MODEL MD900 SERIES
SERVICE LETTER PACKAGE

MODEL MD900[®] ROTORCRAFT (MD EXPLORER[®]) SERVICE LETTERS

Figure 1. Stack-up of Ground Studs at GS402 and GS403

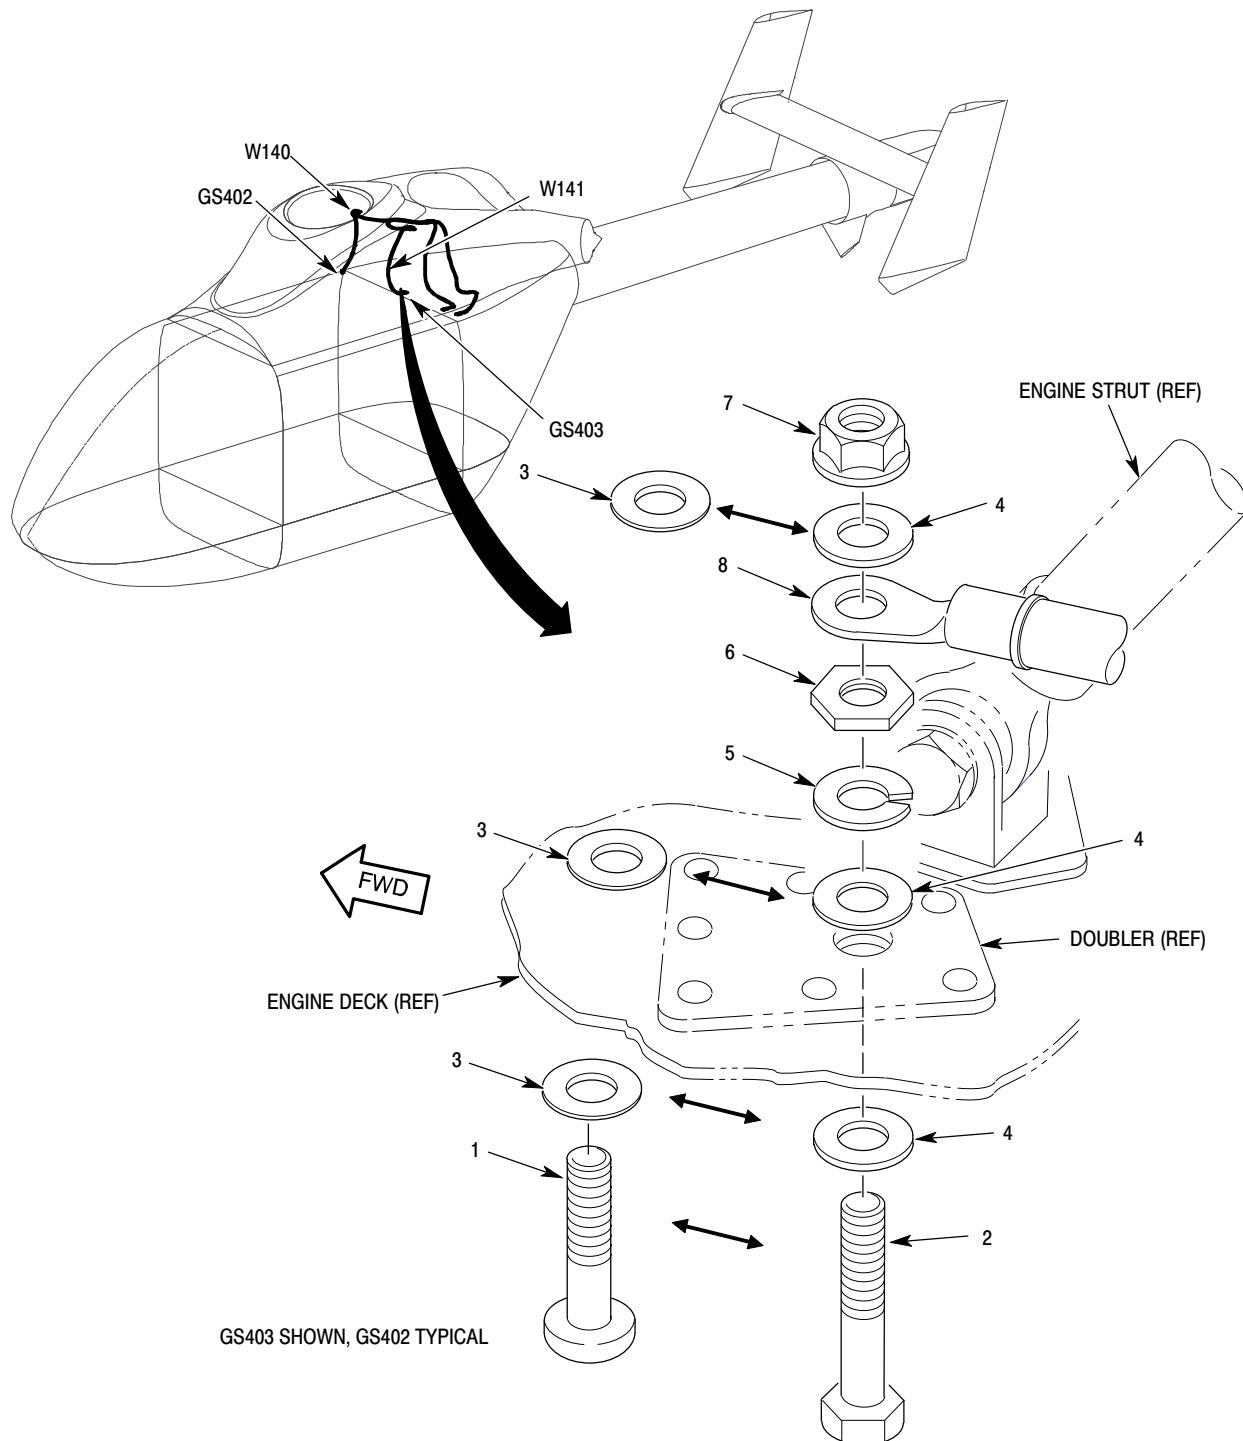
This Service Letter is issued to recommend that operators inspect starter/generator ground studs for arcing, corrosion, and looseness at the next annual inspection. This inspection is necessary to find loose ground studs, or corrosion or arcing that can cause a starter/generator problem. The ground studs are located on the engine deck: right-hand GS402 at STA 225.45 BL 23.12 and left-hand GS403 at STA 228.67 BL -5.15 (ref. Figure 1).

Corrosion cannot be more than **0.012 inch (0.30 mm) deep**. If corrosion on the doubler is more than this limit, contact the Field Service Department at MDHI, and remove and replace the doubler.

To decrease the possibility of incorrect torque, MDHI will no longer use NAS1635-6-16 Phillips-head screws with three AN960JD616L flat washers at each of the starter/generator grounds. AN6C7A hex-head bolts with three NAS1149D0663J flat washers will be used as alternative ground studs on Rotorcraft SN 900-000144 and subsequent. AN6C7A bolts and NAS1149D0663J washers can be purchased commercially by the operator and can be installed on all rotorcraft without modification.

Figure 1. Location of Drain Ports and Installation of Damper Assembly

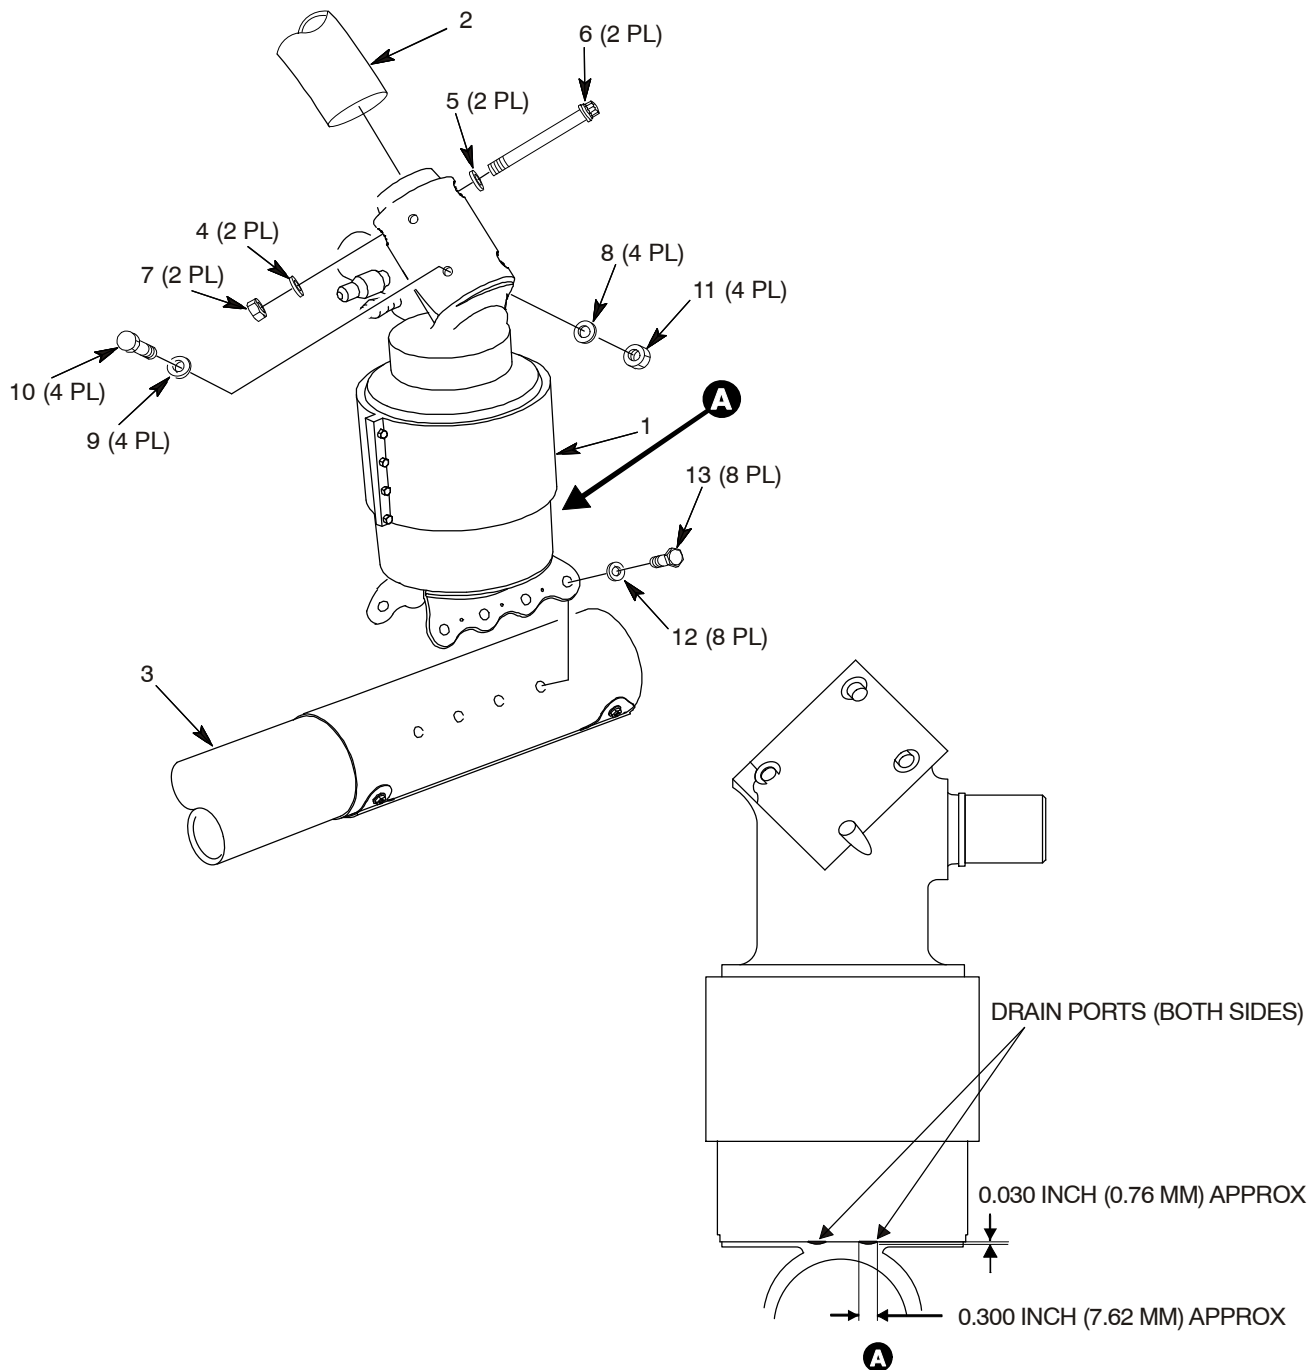
This Service Letter is issued to tell owners and operators to be careful when the corrosion inhibitive sealing compound (C211) is applied to the landing gear damper assembly. Sealing compound (C211) is applied to external mating parts and all fasteners. Too much sealing compound (C211) can cause a blockage in the drain ports of the damper assembly (ref. Figure 1). The drain ports let moisture exit the damper assembly. Blocked drain ports can cause internal corrosion in the damper assembly. Corrosion can reduce the function and life of the damper assembly.

During installation of the damper assembly, be careful not to cover the four drain ports with sealing compound (C211) (ref. CSP-900RMM-2, 32-00-00, Landing Gear Damper Assembly Installation). Apply masking tape to the drain ports during installation of the damper assemblies to prevent blockage. Remove masking tape after the sealing compound has cured.

Inspect the damper assemblies at the next inspection to make sure there is no blockage. If there is blockage, use a brush or scribe or other tool to remove unwanted sealing compound (C211) from the drain ports. Make sure the drain ports are not clogged with unwanted material after repair.

Figure 1. Location of Thruster Assembly Washer Modification

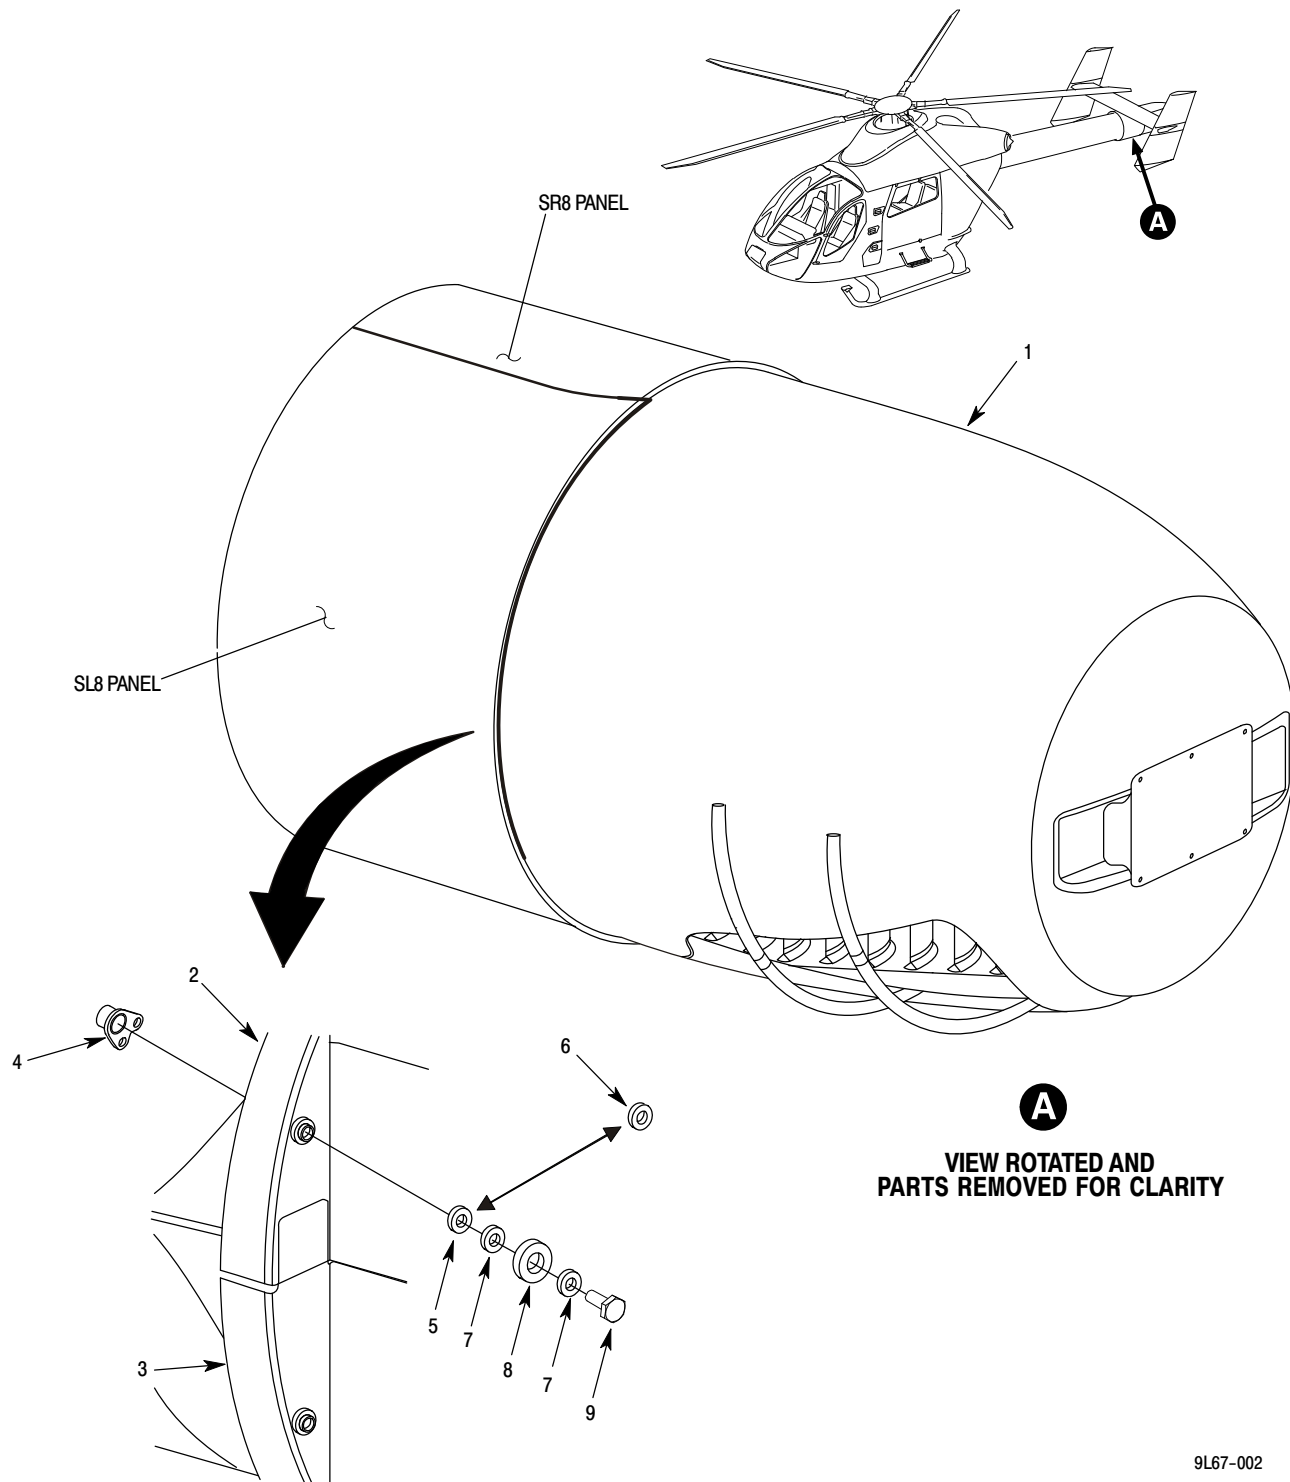
This service letter is issued to tell owners and operators that the control bearing (ref. Figure 1) for the rotating cone assembly may not move freely because the attaching bolts have been over-torqued during installation. Torque more than **30 in-lb (3.4 Nm)** can cause the nylon flat washers to extrude and cause an interference with bearing rotation. At the next bearing inspection/replacement interval, MDHI recommends the removal of flat nylon washers, PN NAS1515H3L (5), and their replacement with corrosion-resistant steel (CRES) flat washers, PN NAS1149C0363R (6). The CRES flat washers are thicker and provide increased clearance from the face of the thruster bulkhead.

At the next access to, or during scheduled maintenance to the control bearings, replace flat nylon washers with CRES flat washers. Install control bearings with new washer in the thruster assembly. Correctly torque bolts **15 to 20 in-lb (1.7 to 2.3 Nm)** plus run-on torque to get the correct locking torque on the nutplate. If it is necessary to remove remaining axial play of the stack-up, torque bolts to **24 in-lb (2.7 Nm)** maximum.

Figure 1. Inspection of the Mast Assembly

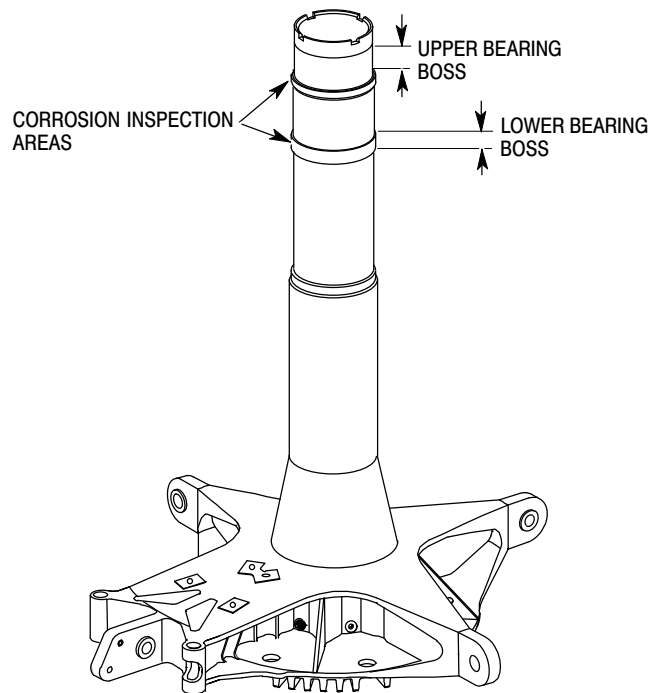
Make sure the mineral grease (C125) is not applied on the surfaces of the mast assembly below the lower bearing boss or above the upper bearing boss. Unwanted material can collect on the grease.

- (3). Apply a thin layer of mineral grease (C125) to the upper and lower bearing bosses before you install the hub assembly.

Figure 1. Repair of the Engine Control Knobs

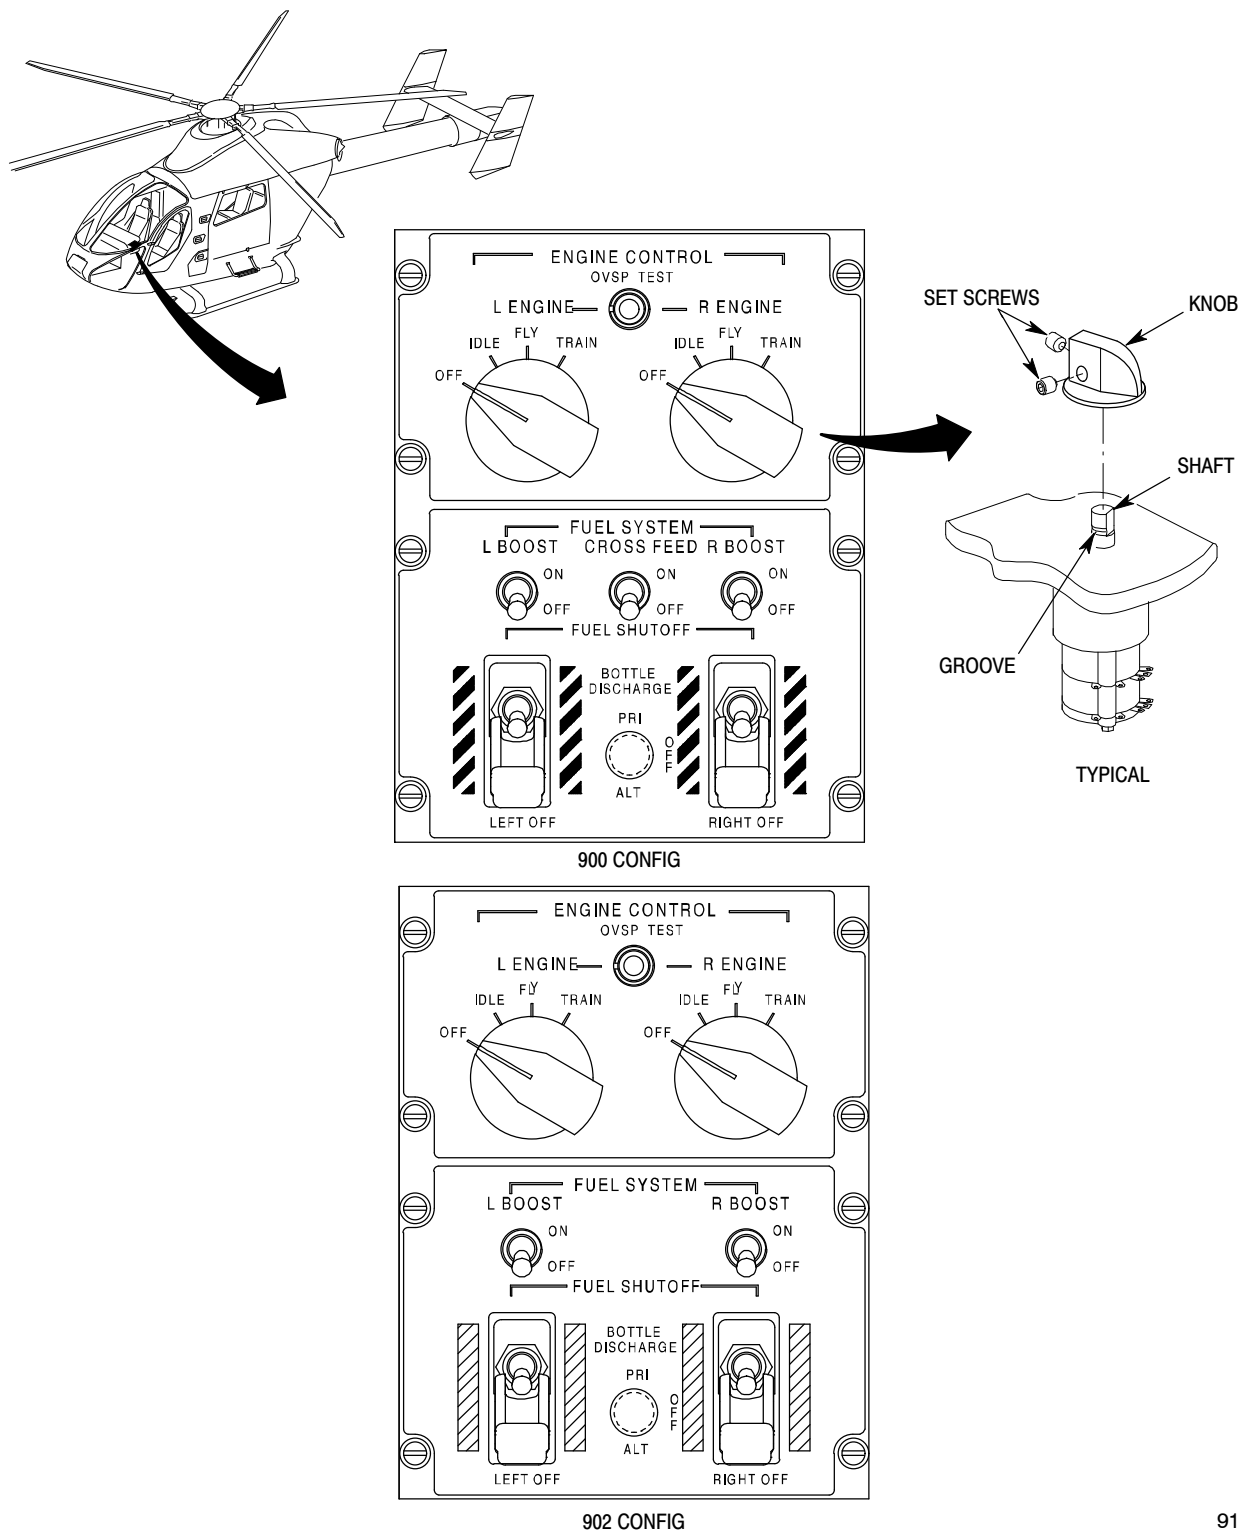
- (4). Apply a small quantity of sealant (C239) (MIL-S-46163, Type 2, Grade N; or an equivalent alternative) to the threads of set screws.
- (5). Install the knobs with the set screws.
 - (a). Make sure that the set screws are installed in the groove of the shaft.
 - (b). Tighten with your hand the set screws.
 - (c). Then tighten the set screws with the applicable Allen wrench.
 - (d). Let the sealant cure for six (6) hours minimum, before flight operations.
- (6). Return power to the rotorcraft.

Figure 1. Location of Control Bearings in the Thruster Assembly

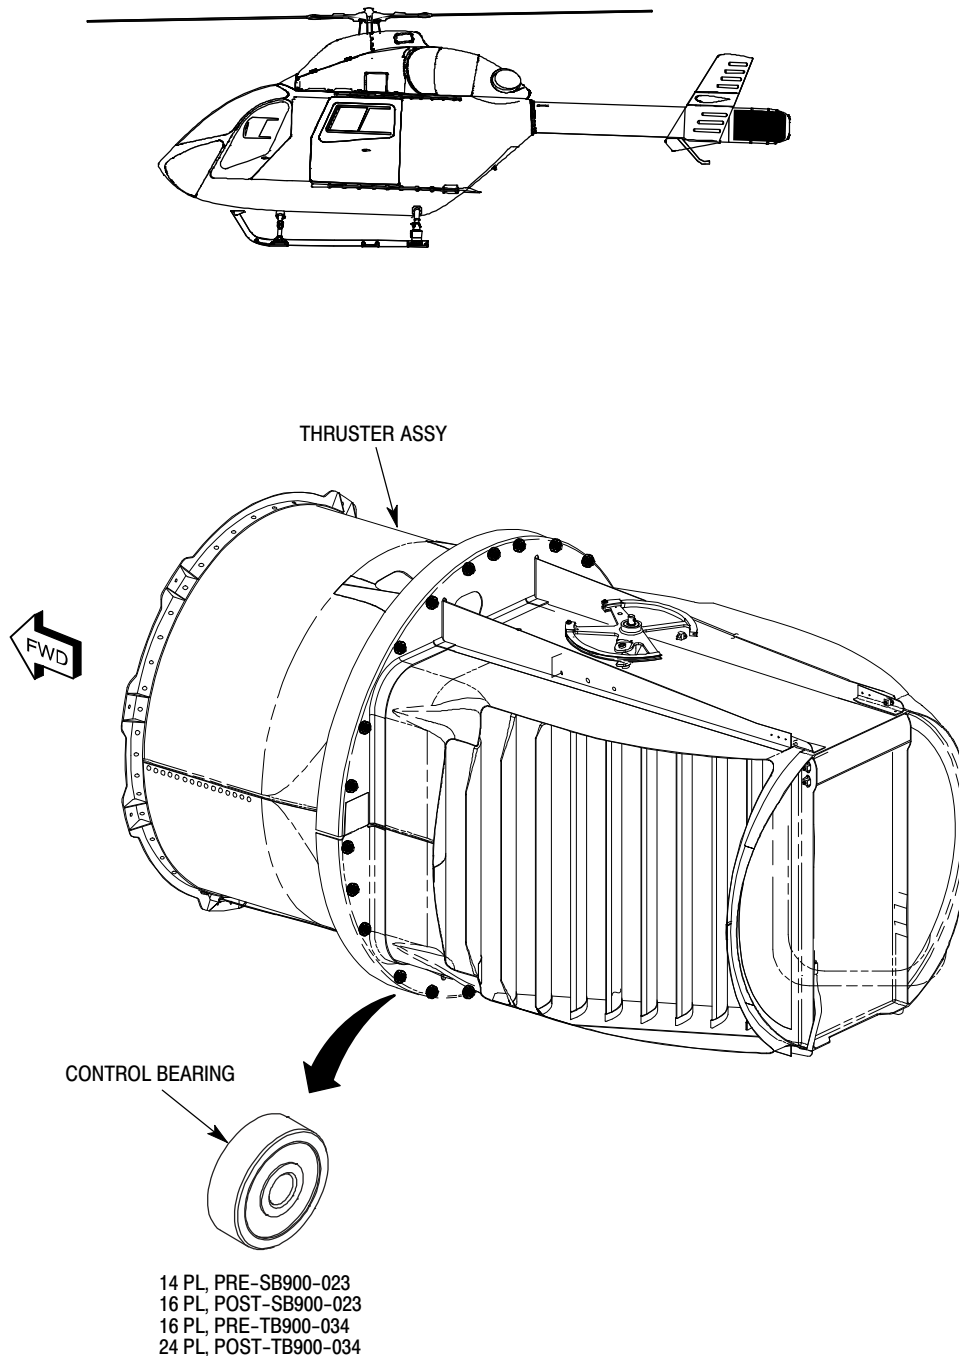
This Service Letter is issued to tell owners and operators that there are alternate Part No. 900F3420003-101 control bearings available to replace CEKP3AR11-2 control bearings as a complete set.
